File 28x10 Screened
in porch

HARNETT COUNTY CENTRAL PERMITTING

APPLICATION # 1850044475

JOB NAME David Jobe Construction

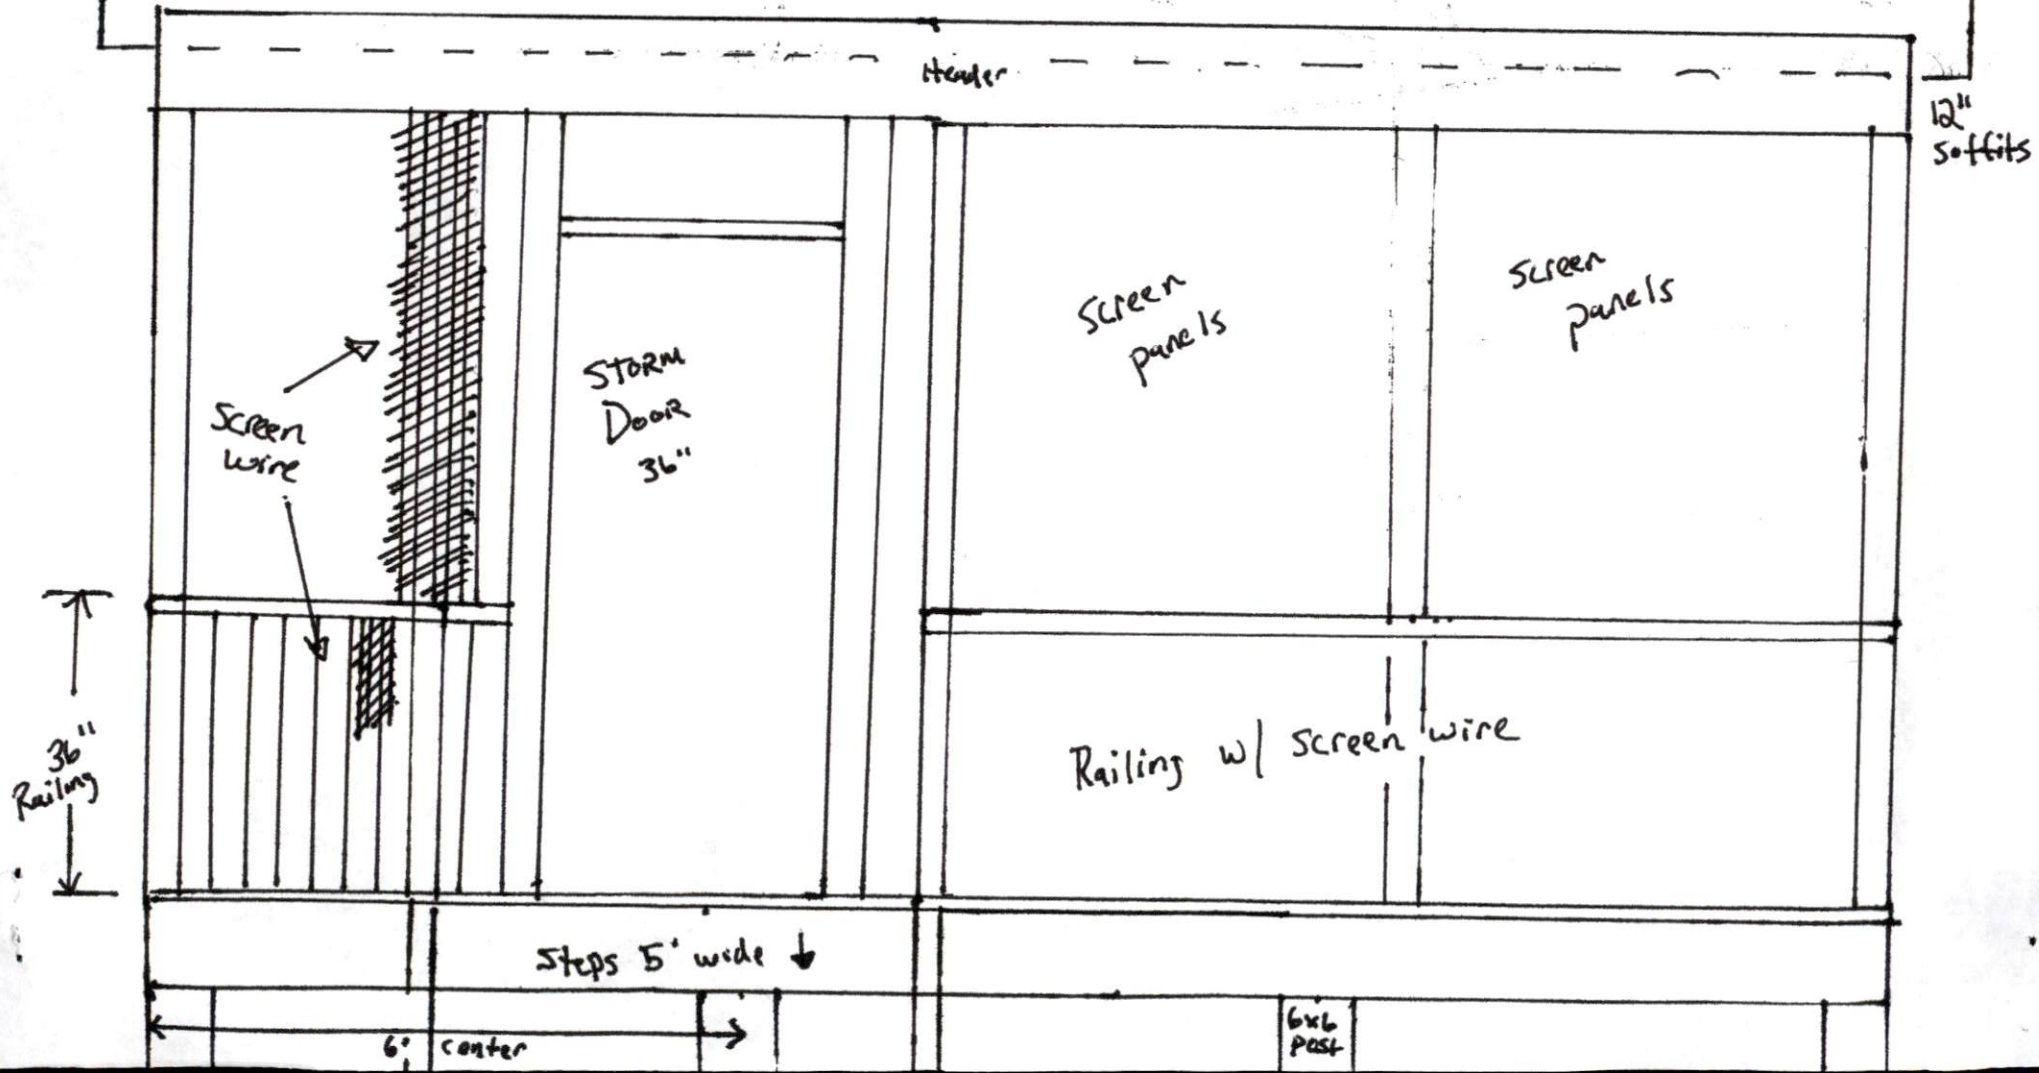
1. No footing sizes. 2. No header sizes. 3. No rafter size 4. No ceiling joist sizes. 5. No post spacing. 6. No floor joist or girder sizing. 7. Need sizing and spacing of materials used.

- 1) Footings 18"x18" with 4"x8"x16" solid blocks crisscrossed (4) per hole.
- 2) (5) 6"x6" post holding floor approx. 7' on center
- 3) Floor joist 2"x10" (16" on center)
- 4) Header size 2"x10" double
- 5) Rafter size 2"x8" (16" on center)
- 6) No ceiling joist. Bead board on bottom side of rafter
- 7) Band board is 2"x10" double
- 8) No center girder needed on span.
- 9) Post spacing 4"x4" (52" or less for walls).
